ITS CORPORATION					REV	ECN	DATE	APV
APV	THIS PRINT IS THE PROPERTY OF ITS CORP IT SHALL NOT BE COPIED WITHOUT PERMISSION		TITLE SCHEMATIC SCADA BOARD (1555-1233)					
DATE	MATERIAL		DWG. NO.					REV
ECN	-----		DWN	DLM	1/9/96	1555-3233		4
REV	FINISH		CHK	RAS	1/18/96	SCALE ---		SHEET 1 OF 1
	-----		REL	RAS	1/18/96

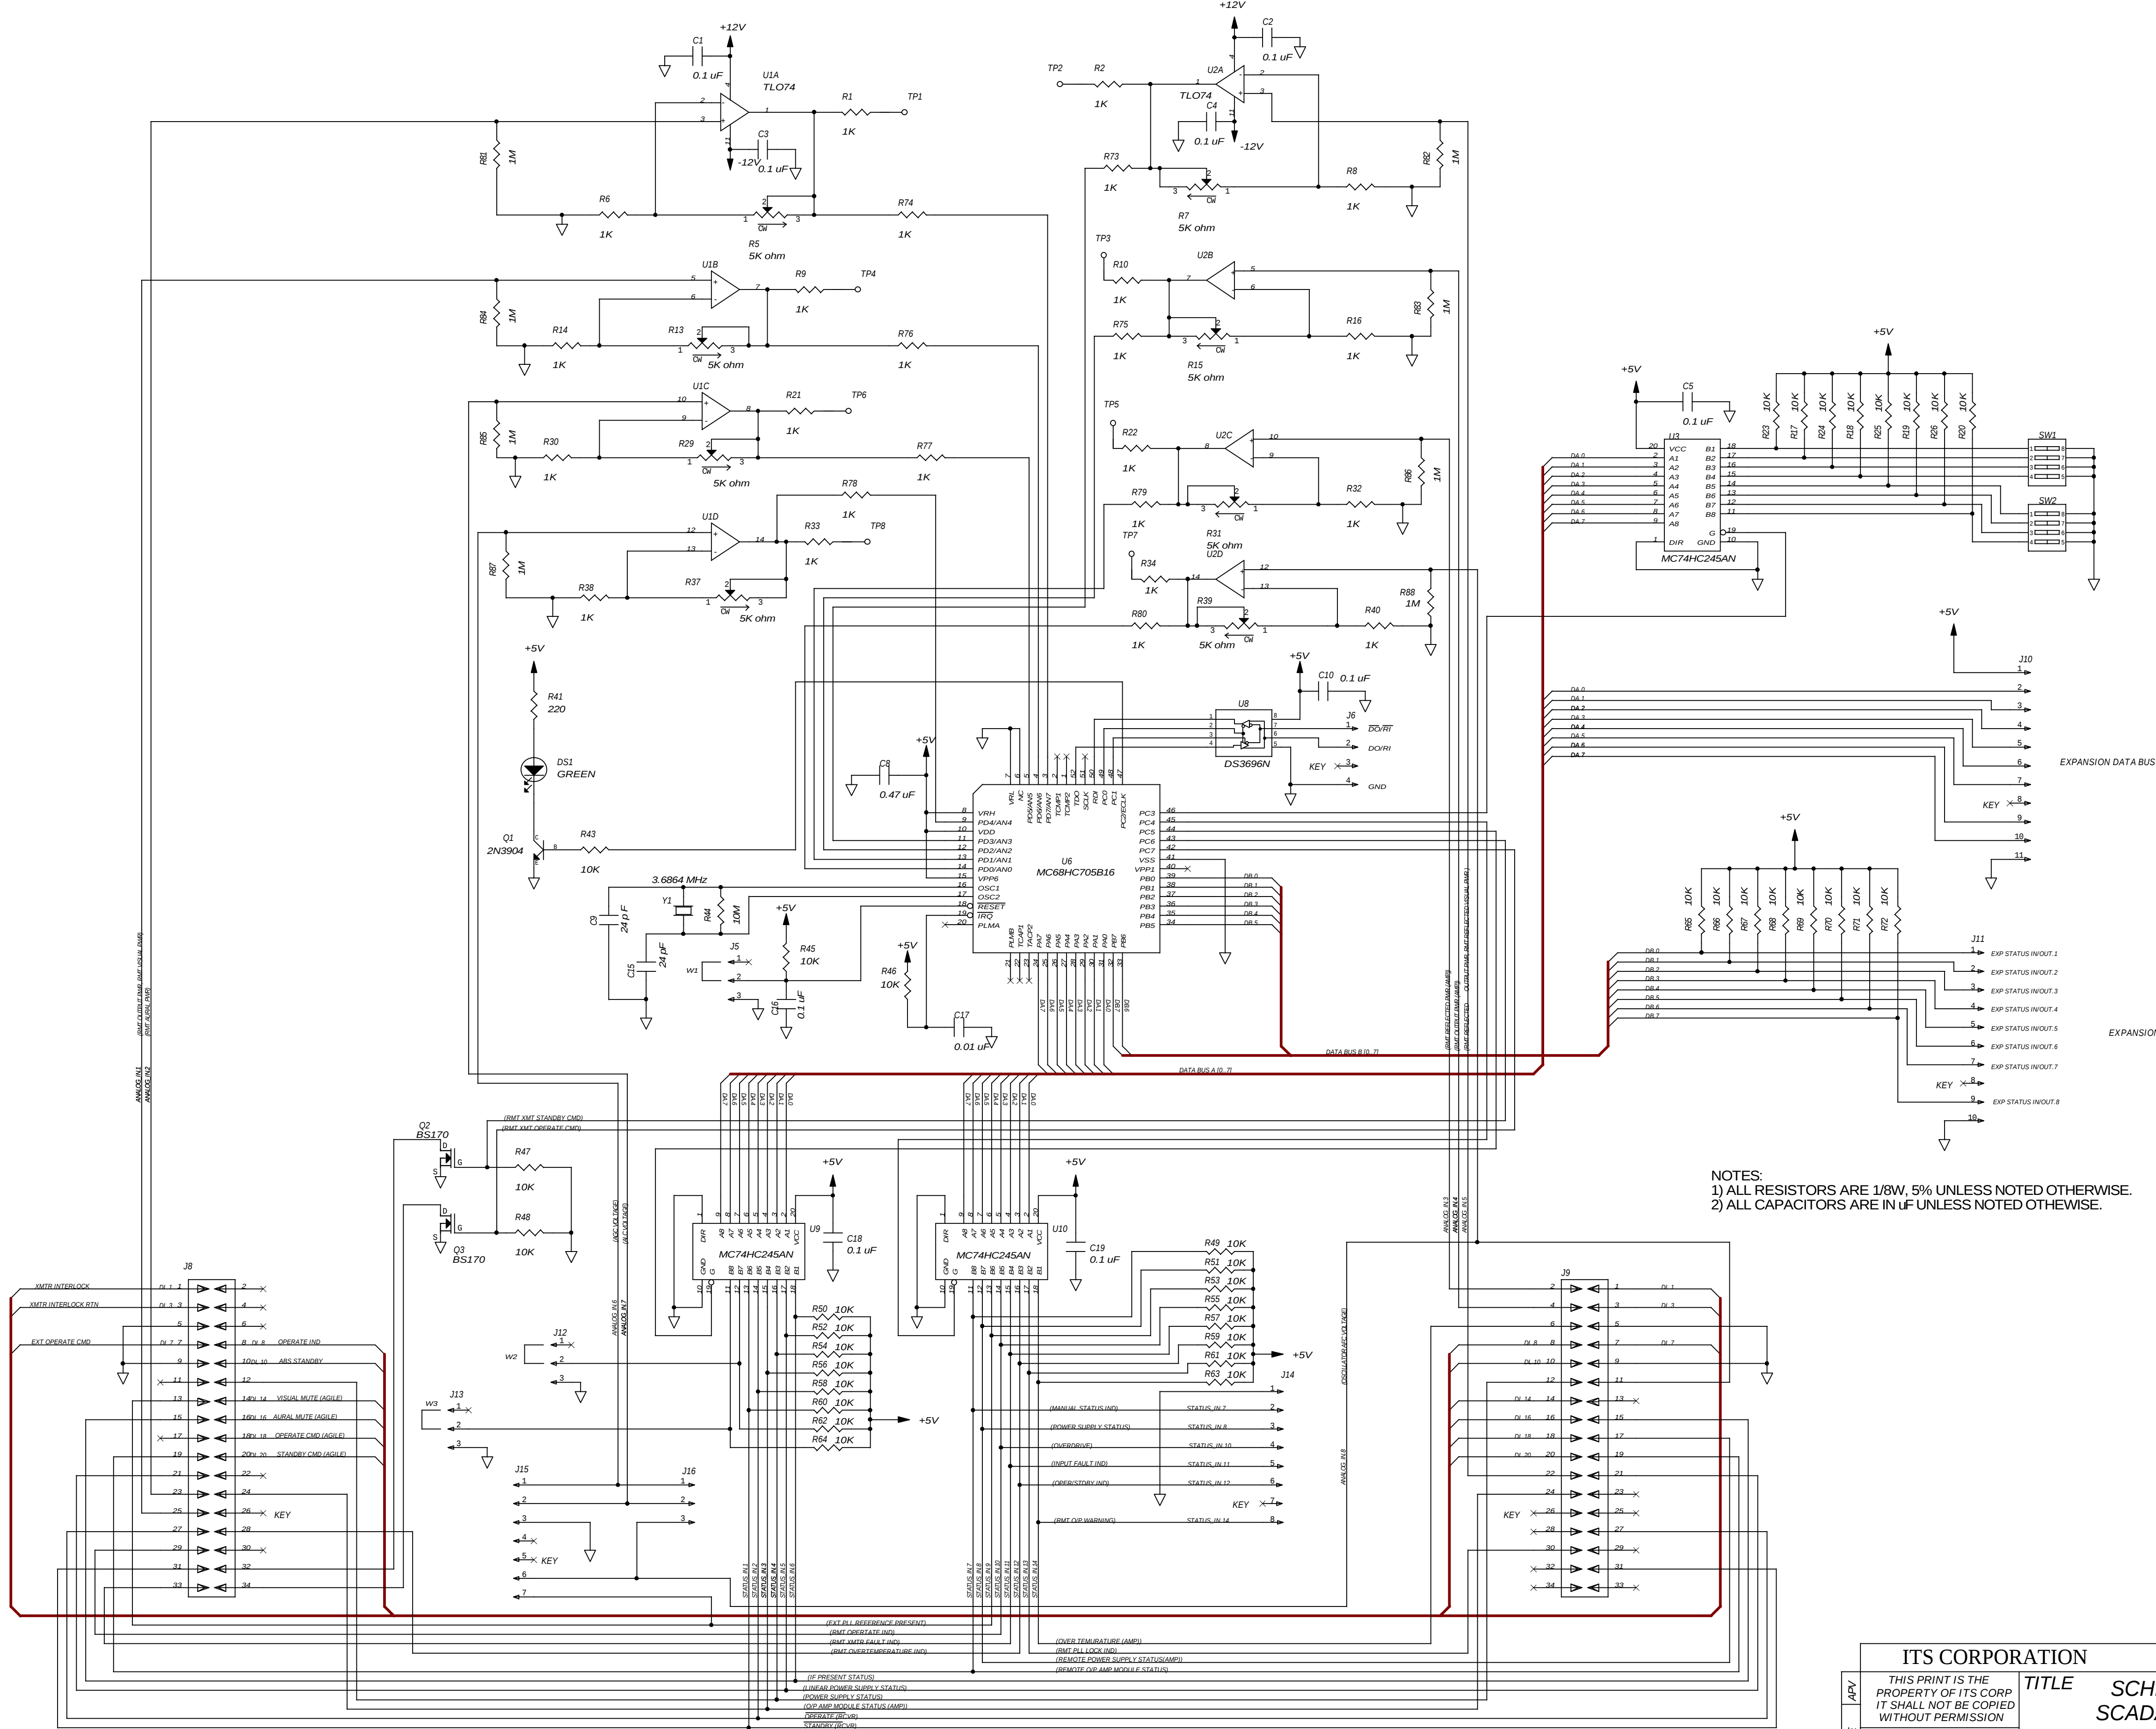
DELETED CONNECTION
BETWEEN R46 AND J8-10.
DELETED R3, R4, R11
R12, R27, R28, R35, R36.
CONNECTED U6-6 TO
GND. ADDED NOTES 1
AND 2. (PJK)

Y1 WAS 4.0 MHz DLM

DELETED "(AMP)" FROM U10-11.
ADDED "(AMP)" TO U18-15. ADDED

R3,4,11,12,27,28,35,36 WAS 470 OHMS
ADDED (8) 1 MEG RESISTORS TO U1
